ATS & PFSP YANG maintenance item #0392 & #0393 ver 1.0

Maintenance item

- ATS schedulers and scheduler-groups YANG containers don't align with 802.1Q-2022
- Multiple Scheduler Instance Tables and Scheduler Group Instance Tables are created in a bridge components

- Need a clarification of using stream-filter when a bridge uses both ATS and PSFP

Figure 48-16—Asynchronous Traffic Shaping model

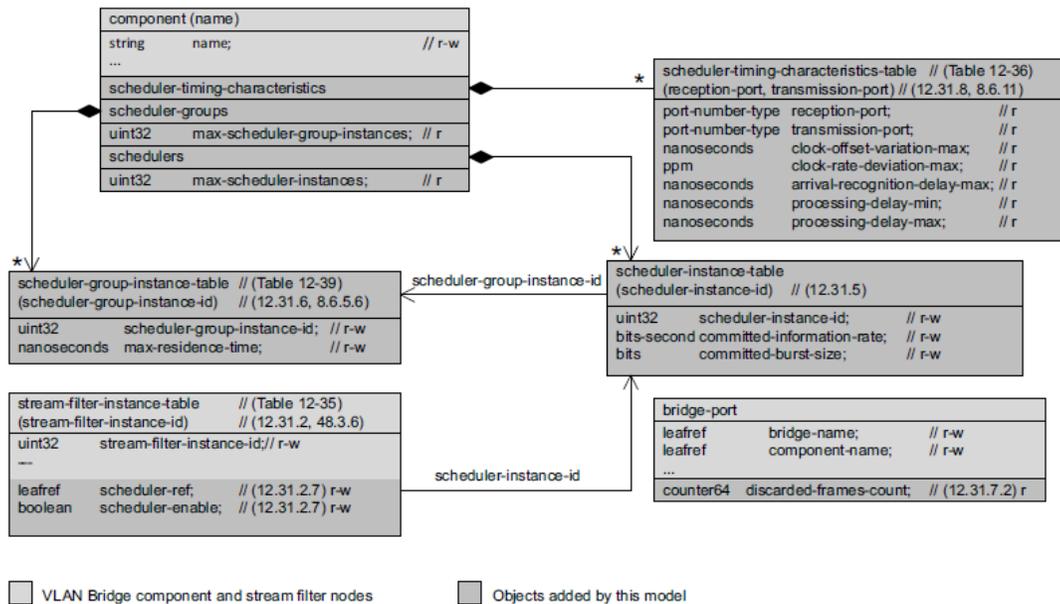
- **ATS YANG module (clause 48.5.13) includes *scheduler-instance-table* and *scheduler-group-instance-table* under *stream-filter-instance-table[]*.** This causes multiple *scheduler-instance-tables* and *scheduler-group-instance-tables* under *stream-filter-instance-table[]*
- **However, Clause 12.31.5 & 12.31.6 state**
 - There is *one Scheduler Instance Table* per *Bridge Component*. ...
 - There is *one Scheduler Group Instance Table* per *Bridge Component*. ...
- **YANG and statements of clause 8.6.5.6, clause 12.31.5, clause 12.31.6, clause 48.2.6 & clause 48.2.7 don't match.**

- Move “*container schedulers*” and “*container scheduler-groups*” out from “*grouping ats-parameters*” of `ieee802-dot1q-ats` YANG module to as a container under “*augment “/dot1q:bridges/dot1q:bridge/dot1q:component”*”

```
augment "/dot1q:bridges/dot1q:bridge/dot1q:component" {
...
  container ats-parameters {
    description
      "Container for ATS parameters";
    container schedulers {
...
      list scheduler-instance-table {
        key "scheduler-instance-id";
        leaf scheduler-instance-id {
          type uint32;
          mandatory true;
        }
        leaf committed-information-rate {
          type uint64;
          units "bits/second";
          mandatory true;
        }
...
      }
      container scheduler-groups {
...
      }
...
    }
  }
...
  uses sfsg:sfsg-parameters {
    augment "lm-ats:stream-filters/lm-ats:stream-filter-instance-table" {
...
      // uses ats:ats-parameters;
      container scheduler {
        leaf scheduler-ref {
          type lm-ats:scheduler-ref-type;
          default 0;
        }
      }
    }
  }
...
}
```

Figure 8-13—Flow classification and metering

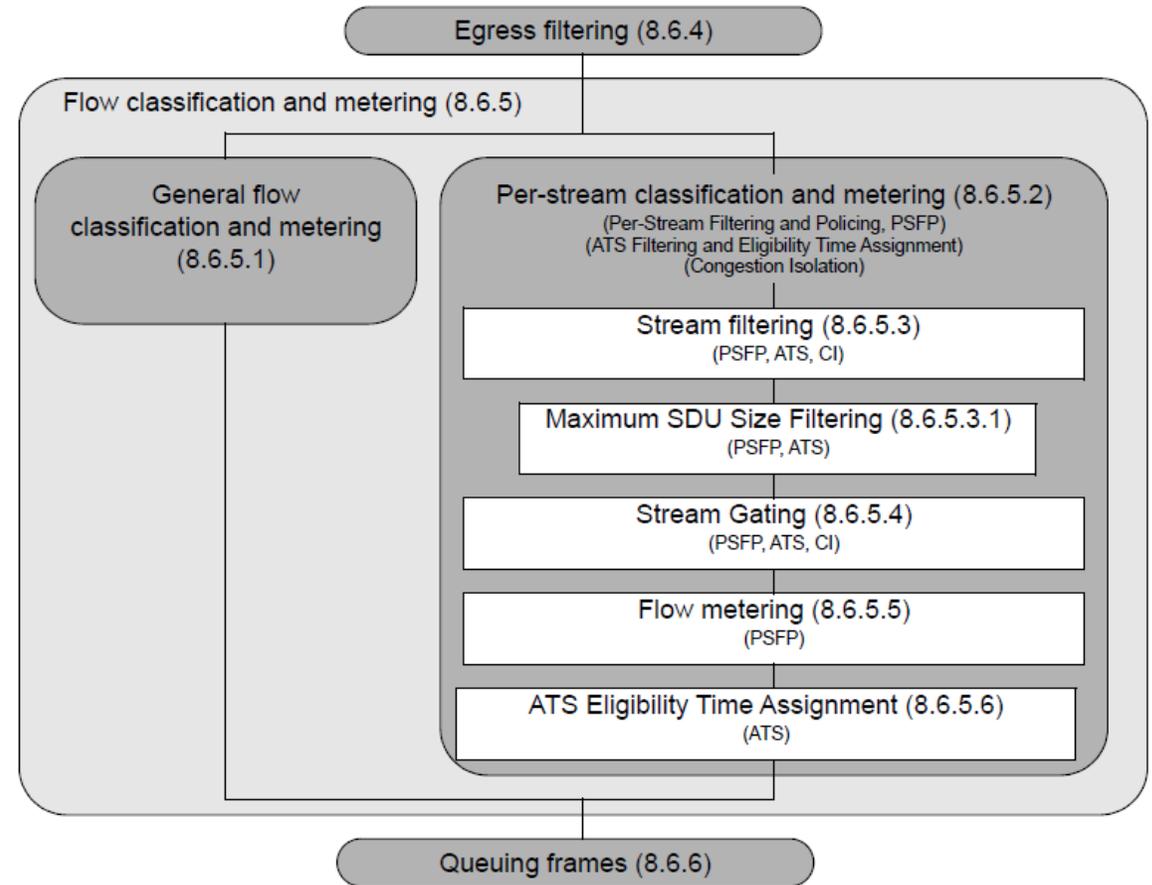
- Per current YANG, PSFP and ATS creates own stream-filter-instance-table (*ats-bridge:stream-filter-instance-table* [stream-filter-instance-id]* & *psfp-bridge:stream-filter-instance-table* [stream-filter-instance-id]*)
In this case, each table can have own *max-sdu-size*, then a single stream can be filtered twice based on two different values of *max-sdu-size*.
- And, this is also problem on *admin-ipv* of *stream-gate-instance_table* on both PSFP and ATS.

- **802.1-2022 (and P802.1-2022-Rev-D1.6) states that “*PSFP and ATS share common per-stream classification and metering elements, as shown in Figure 8-13.*”**

But, no clear mention (or definition) that each function (or module) can/shall have own stream-filter table.

- **We think this should be clarified in 802.1Q that how *stream-filter* and *stream-gate* are defined/used when multiple functions of PSFP, ATS and CI are used in a bridge.**
